CONSTRUCTION PLANS FOR WALTON OAKS

CITY OF ROCHESTER HILLS, OAKLAND COUNTY, MICHIGAN

Site Plan Review
Reviewed for compliance with City Ordinance, Building and Fire Codes
Conditions and mark-ups noted throughout plan set must be addressed prior to final approval

WALTON OAKS COVER SHEET
WALTON BOULEVARD, CITY OF ROCHESTER HILLS
THREE GENERATIONS ROCHESTER HILLS SITE PLANS

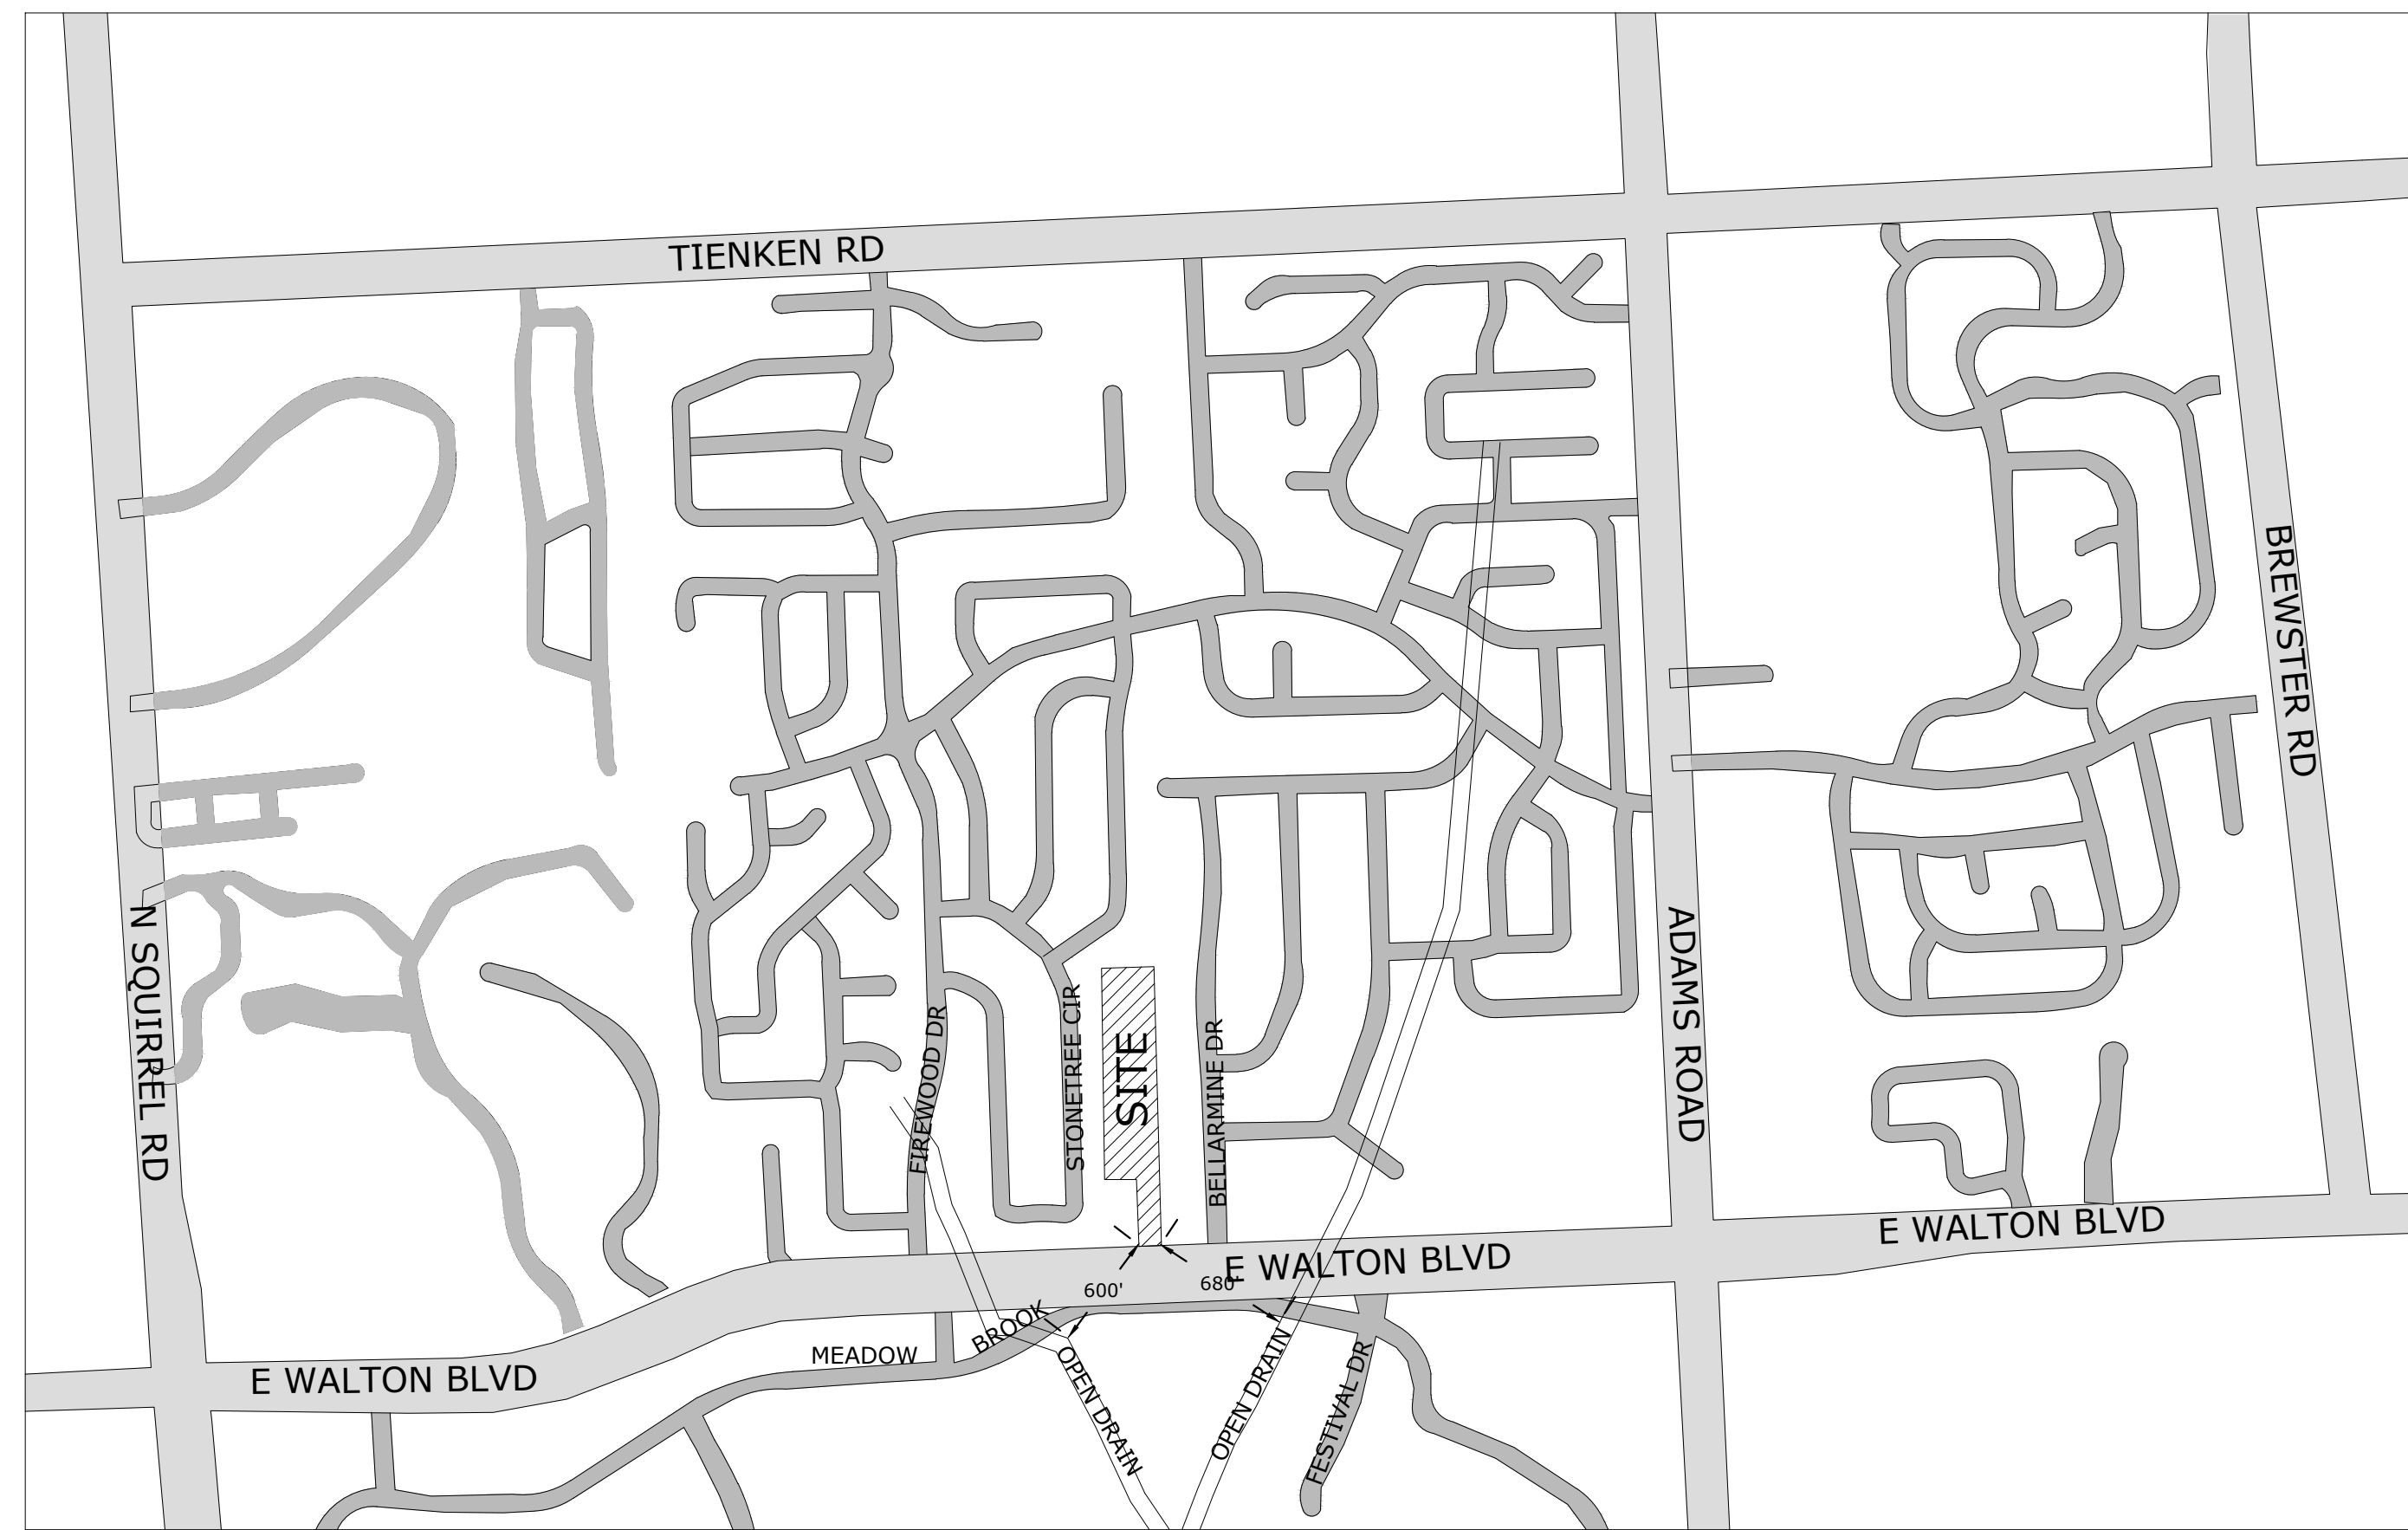
Just a note that the proposed retaining walls will need to be approved prior to overall construction plan approval. Submit the revised retaining wall plans once the revisions have been made.
